TM 11-6625-496-45

TEST SET, RADIO AN/VRM-l

Change
No. 6

General Support and Depot Maintenance Manual Including Repair Parts and Special Tools Lists TEST SETS, RADIO AN/VRM-1 AND AN/VRM-1A (NSN 6625-00-892-5542)

Figure 9. Tests in *selector switch positions A. 2..3, and 7. simplified schematic diagram.*

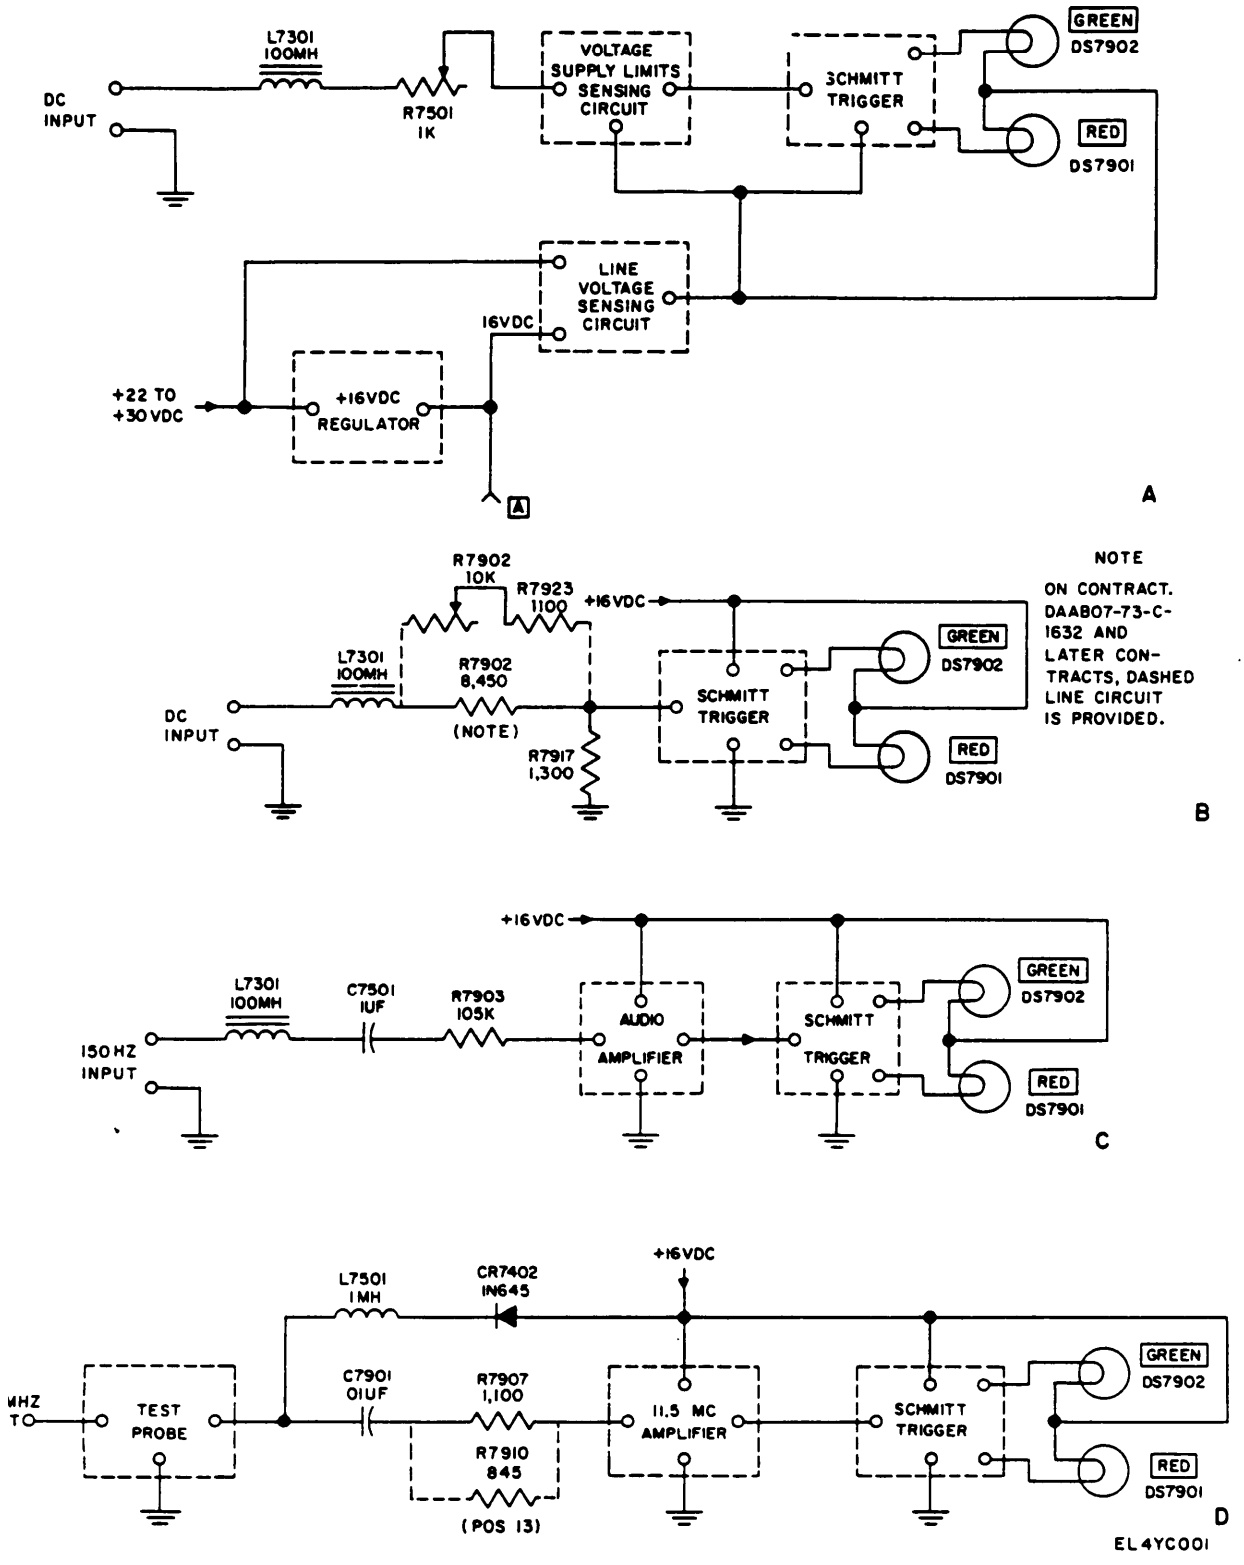
Page 12, paragraph 14. Add the following sentence after the second sentence:
In some equipment (para 1d(5)(d)), the test voltage is connected through rf choke L7301 and across voltage divider network consisting of variable resistor R7902 and resistors R7923 and R7917 (fig. 9.1).

Page 13. Figure 9 is superseded by a new figure 9.

Figure 10.1. Test in selector switch position 19. simplified schematic diagram.

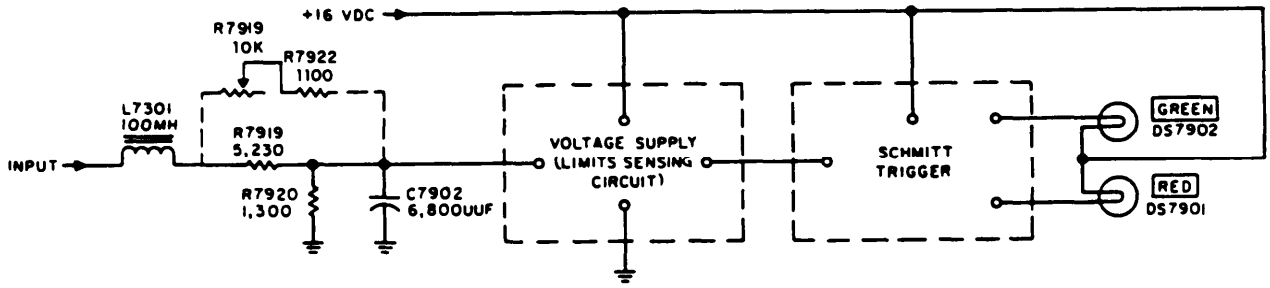
Figure 10.1 is superseded by new figure 10.1.

Figure 11.2. Selector switch S7901, wiring diagram; applicable to equipment with potentiometers R7902 and R7919; TS-1777A/VRC.

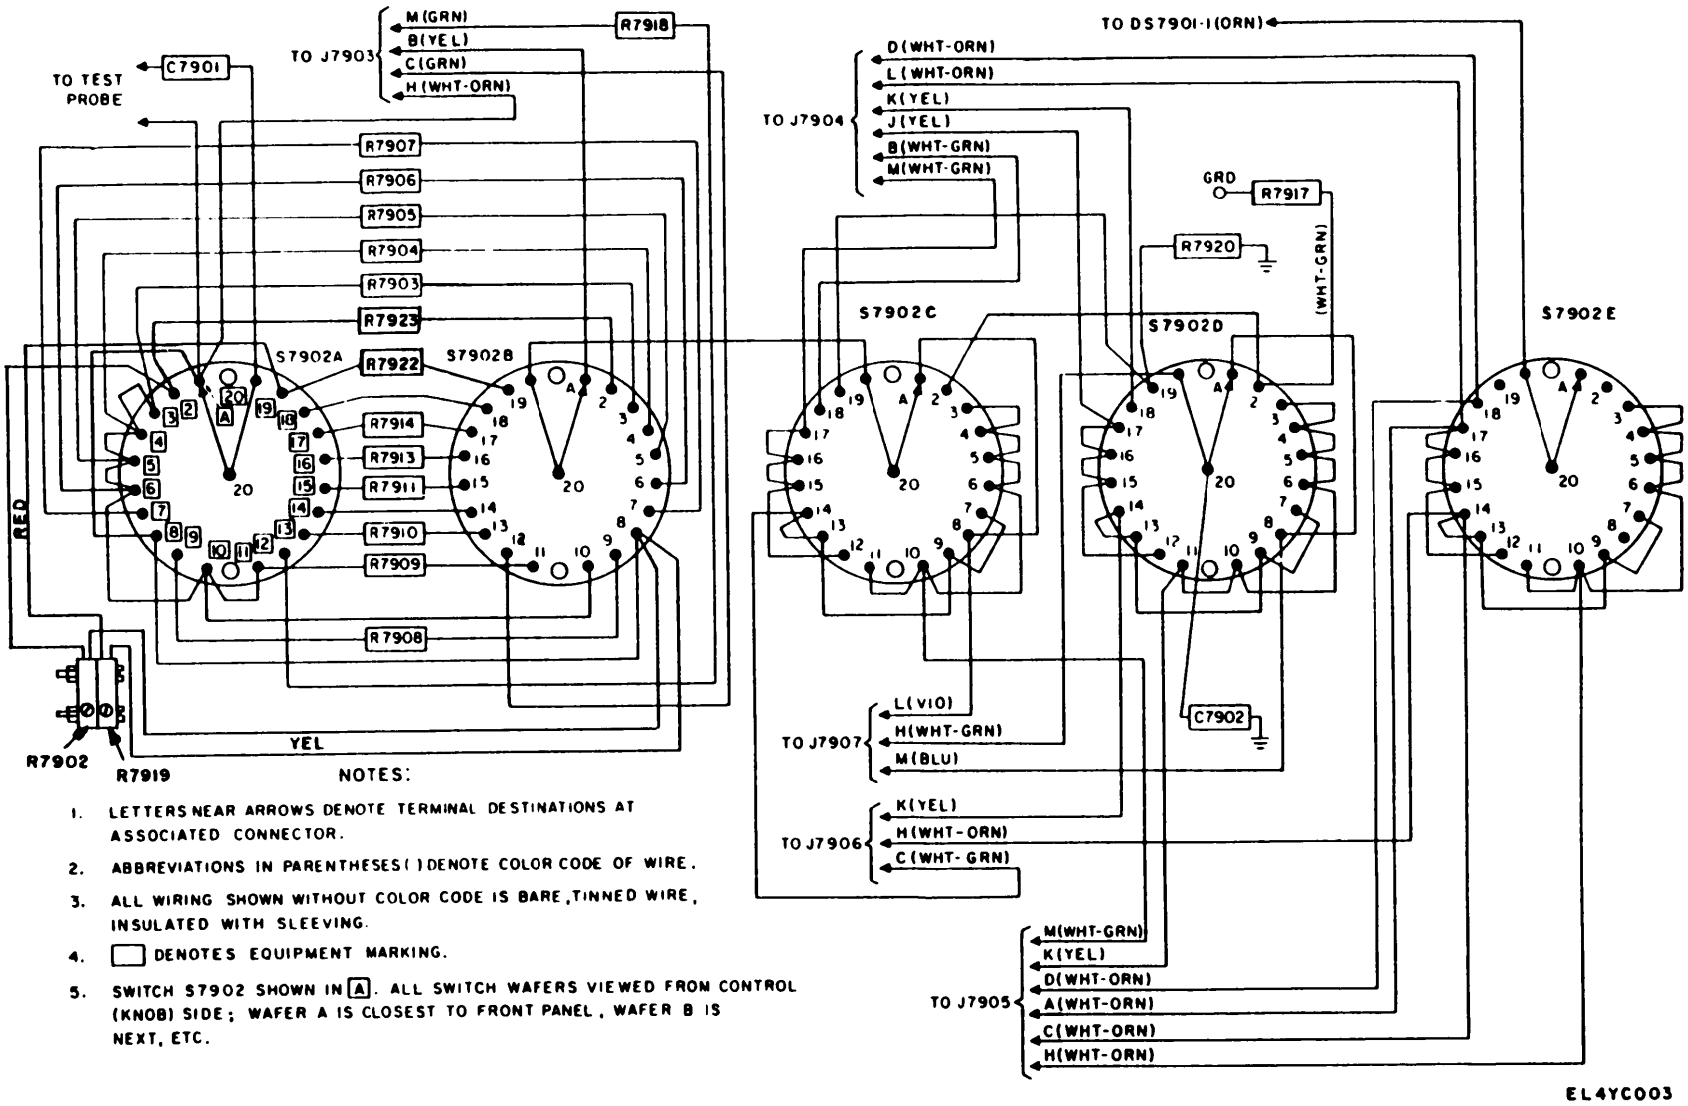
(d) The TS-1777A/VRC exhibited problems in sensitivity caused by lack of adjustment capabilities for positions 2 and 19 of the selector switch. Fixed resistors R7902 (position 2) and R7919 (position 19) (fig. 11). respectively. have been replaced with variable resistor R7902 in series with fixed-film resistor R7923 and variable resistor R7919 in series with fixed-film resistor R7922 (fig. 11.1). Resistors R7922 and R7923 prevent overheating of transistors Q7802, Q7803, and associated components if the variable resistors arc set for minimum resistance. The minimum resistance setting of R7902 and R7919 results in the full input signal level of 20 volts applied to the base of Q7802, which is in the full input signal level of 20 volts applied to the base of Q7802, which is in excess of the normal trigger voltage of 2.6 volts. The resul -

Page 23. New figure 11.2 is added after figure 11.1.

For R7902 figure 11.2 adjust to occur at 20.0 volts 65l for R7119 fig. 11.2 adjust to occur at 13.75 volts.

Figure 15. Test Set, Radio TS-1777/VRM-1 and TS-1777A/VRM-1 *front panel chassis, top view.*

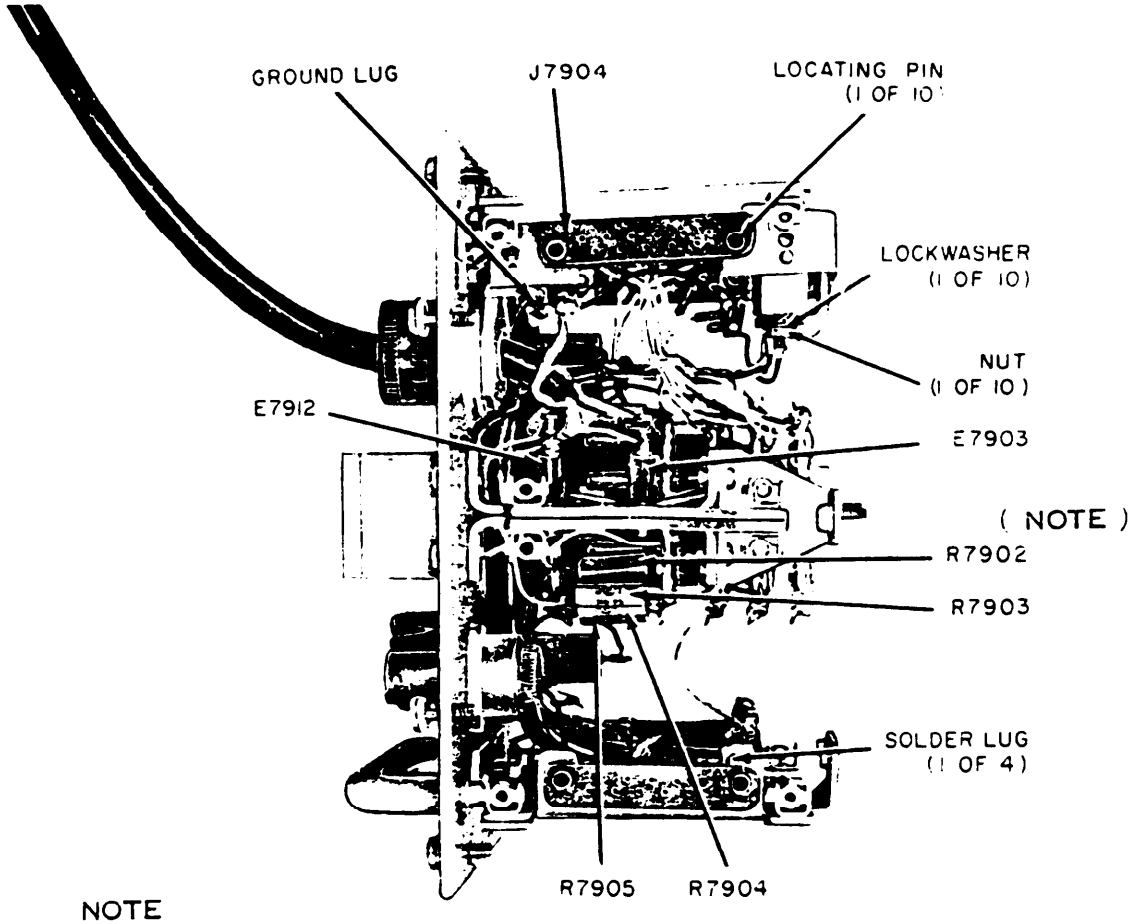
Figure 15 is superseded by a new figure 15:

R7902 IS R7923 (1100 OHMS) WHEN POTENTICMETERS R7902 AND R7919 ARE PROVIDED ON CONTRACT DAAB05 -73 – 6 - 1632 (1973) AND SUCEEDING CONTRACTS.

Figure 11. Selector switch S7902, wiring diagram.

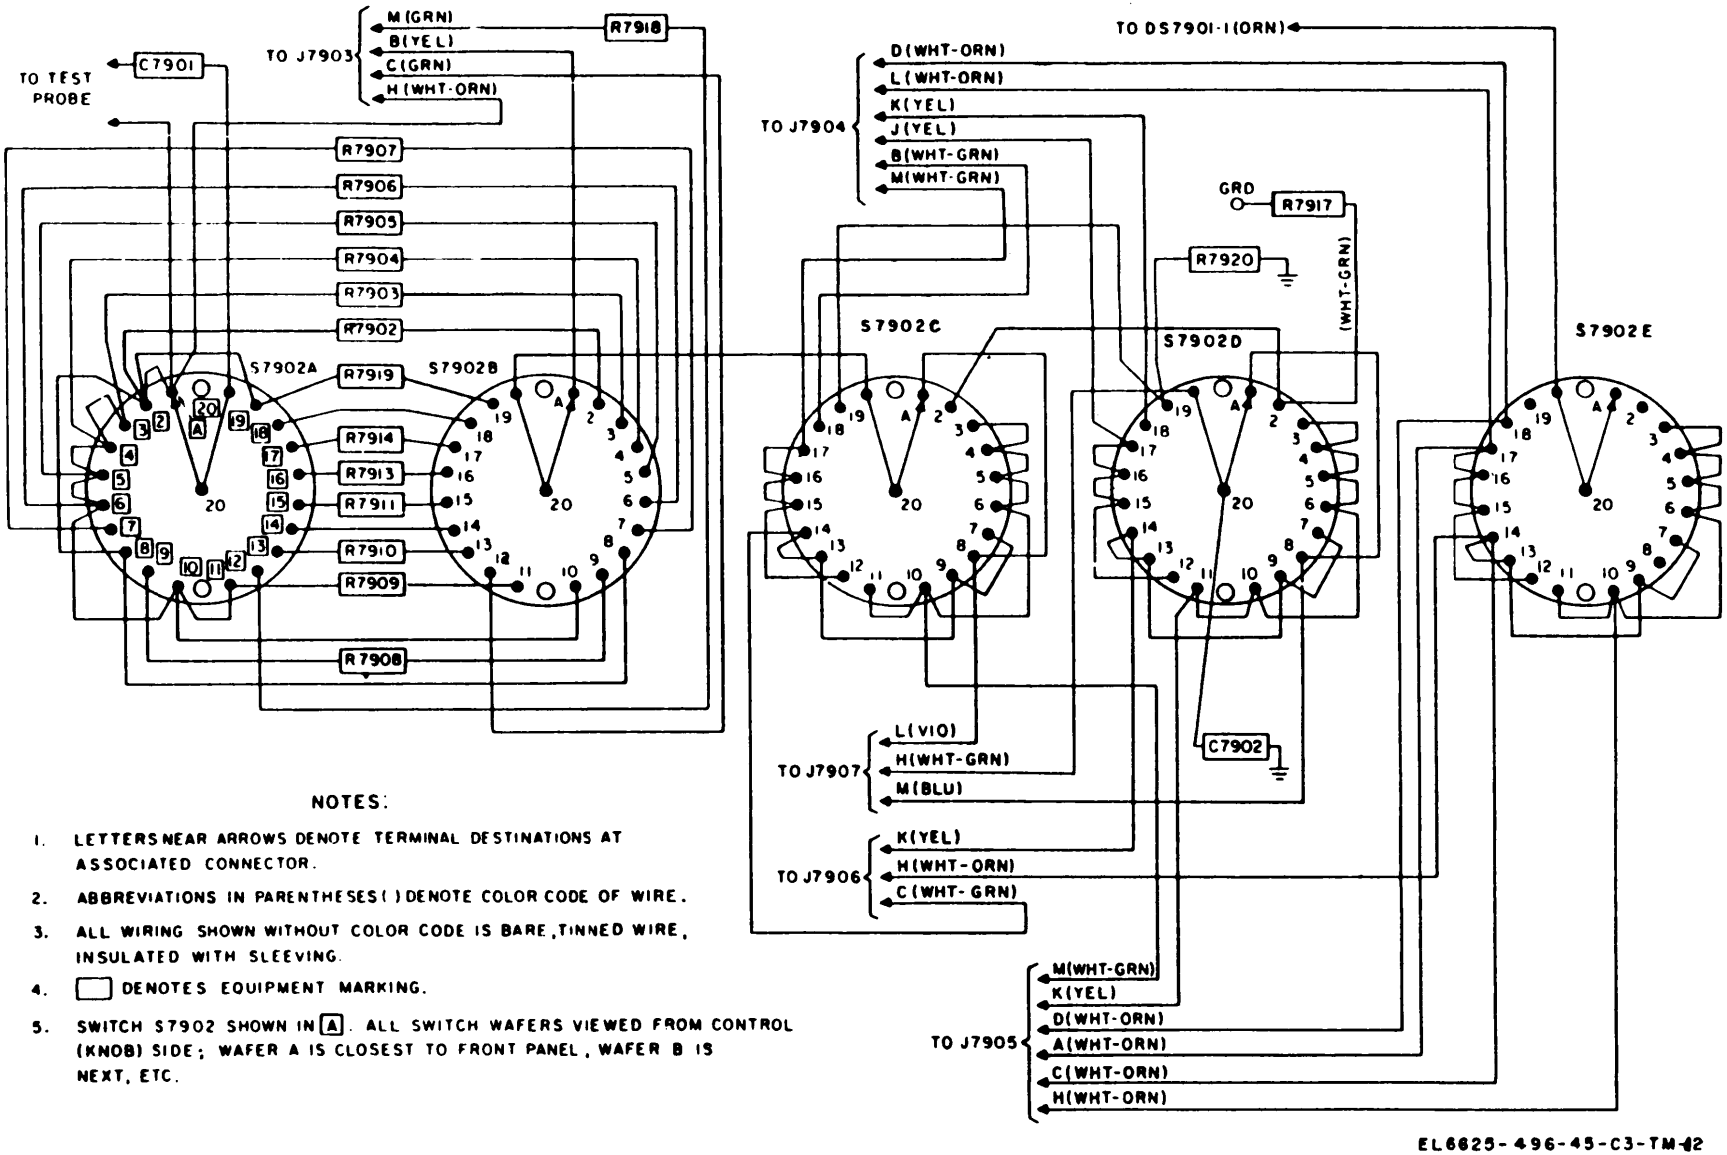
Page 23. Delete figure 11 and substitute new figure 11.

Figure 23.1. TS-1777A/VRM-1 (and later production units of TS-1777/VRM-1), bottom view and location of adjustable controls.

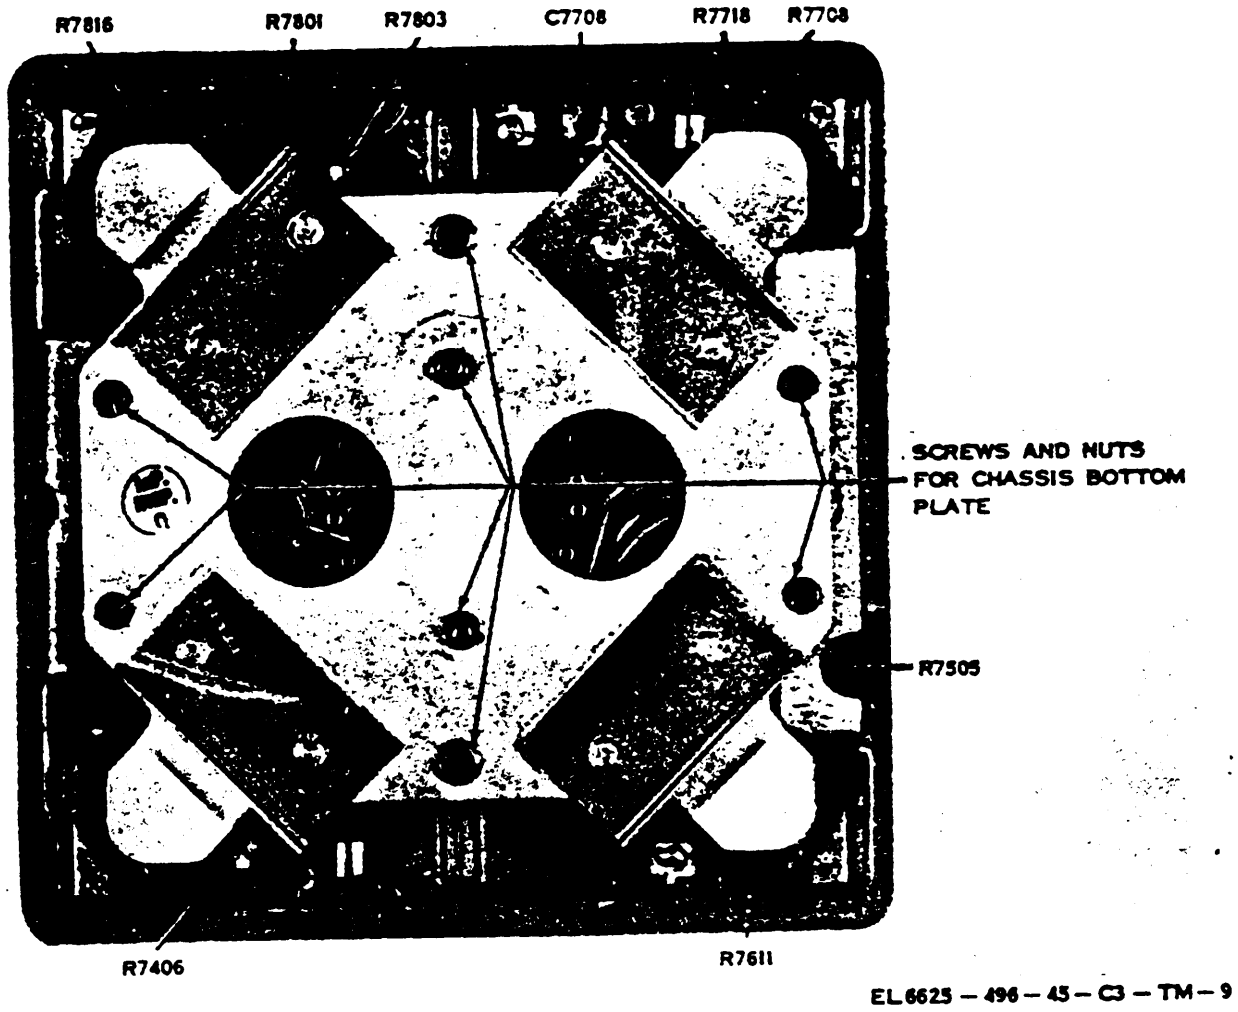
Page 37. Add new figure 23.1 after figure 23.

Figure 5.1. Test probe RF preamplifier, showing changes in wiring of components.

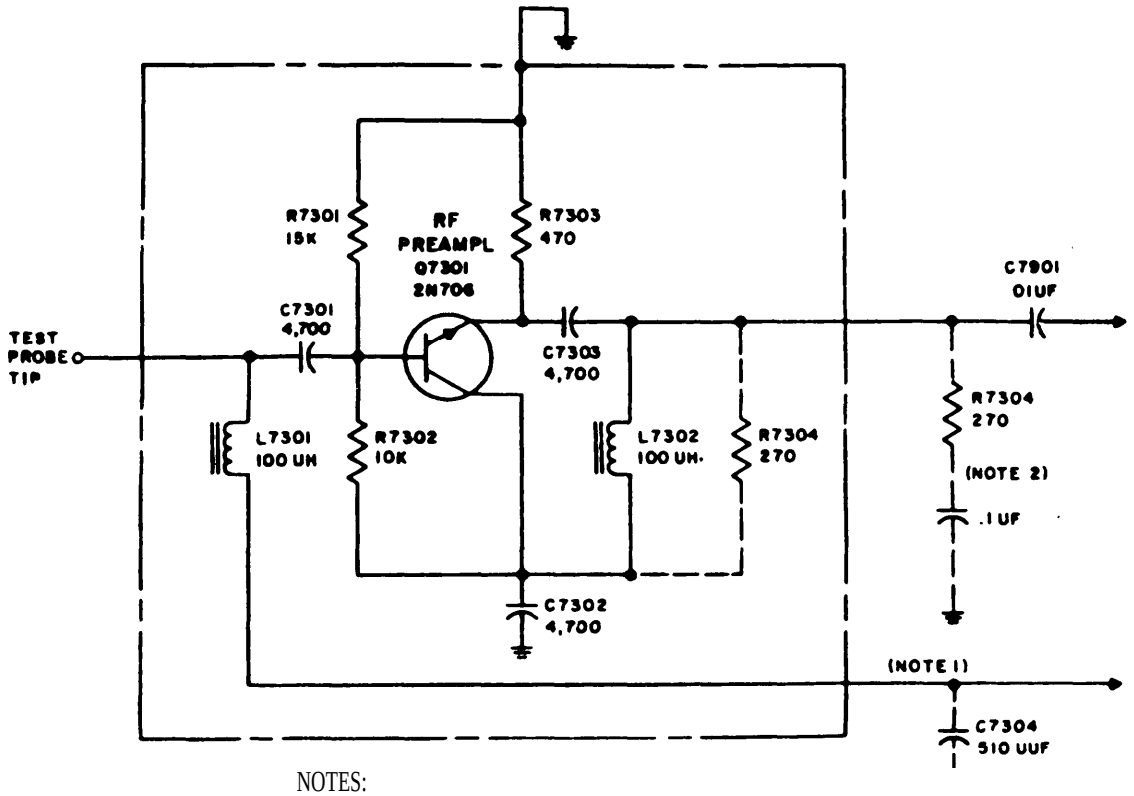
(3) To eliminate undesired high frequency oscillations, some RF amplifier test probes have been modified as follows (note 1, fig. 5.1).

(b) Resistor R7304 and C7304 have been wired in as shown in figure 5.1.

(4) To eliminate undesired high frequency oscillations in RF amplifier test probes that me permanent] y sealed, components have been added to the test probe outputs (note 2, fig. 5.1) as follows:

Page 8. (As added by C 1, 13 Jan 64) After figure 5, insert figure 5.1.
